**DRESSING OF SKINNERS
WIRING AND CABLING
GENERAL EQUIPMENT REQUIREMENTS**

1.001 This addendum supplements AT&T Practice 800-612-160, Issue 7.

1.002 This addendum is issued:

Fig 39—Networks—185A Laser Generated Network (LGN)

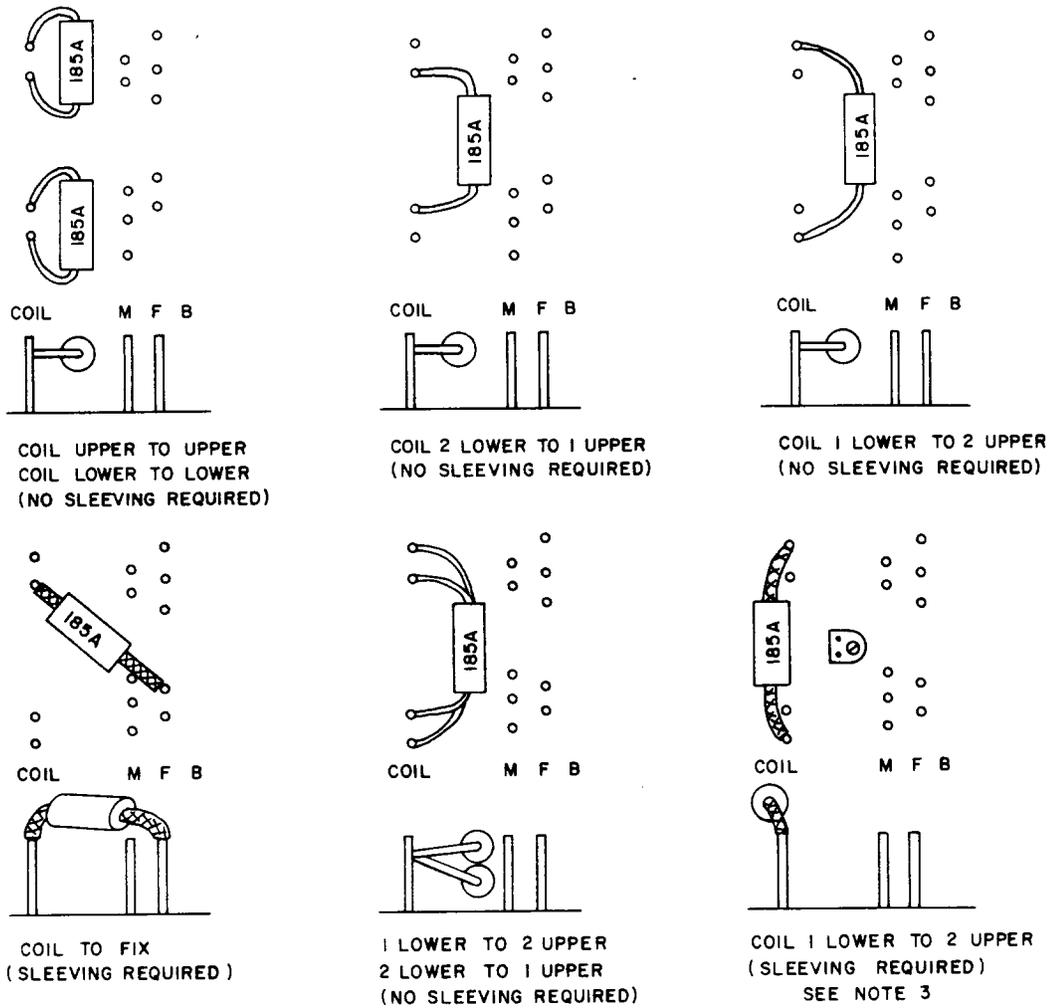
- (a) To add paragraph 2.08.1.
- (b) To revise Fig 39 to show dressing of skimmers to 185A Laser Generate Networks (LGN).

Change: Fig 39

To show:

2.08.1 The 185A Laser Generated Network (LGN) shall be wire-wrapped to relay terminals as shown in Fig 39. Sleeving is not required on the network when wrapped to the primary windings of single or double armature (AK-type) relays or to the innermost windings of AK-type relays with common battery or ground. Sleeving is required on networks across secondary or tertiary windings of multiple wound single armature relays or outermost windings of AK-type relays with common battery or ground. Sleeving is required on all other network connections to apparatus. The network shall be mounted after all wire connections have been made. If the network connection exceeds the allowable number of wire-wrap connections on a terminal, it shall be soldered.

1. A MINIMUM OF 1/32-INCH GAP SHALL BE MAINTAINED BETWEEN THE NETWORK BODY AND "MAKE" TERMINALS, AS GAUGED BY EYE.
2. A MINIMUM OF 1/16-INCH GAP SHALL BE MAINTAINED BETWEEN THE NETWORK BODY AND THE MOUNTING PLATE, AS GAUGED BY EYE.
3. IF TERMINAL PUNCHINGS OR OTHER APPARATUS PREVENTS ONE OF THE SPECIFIED PROCEDURES, THE NETWORK LEADS SHALL BE DRESSED BY OLDER PRACTICES USING KS-785I SLEEVING ON LEADS.
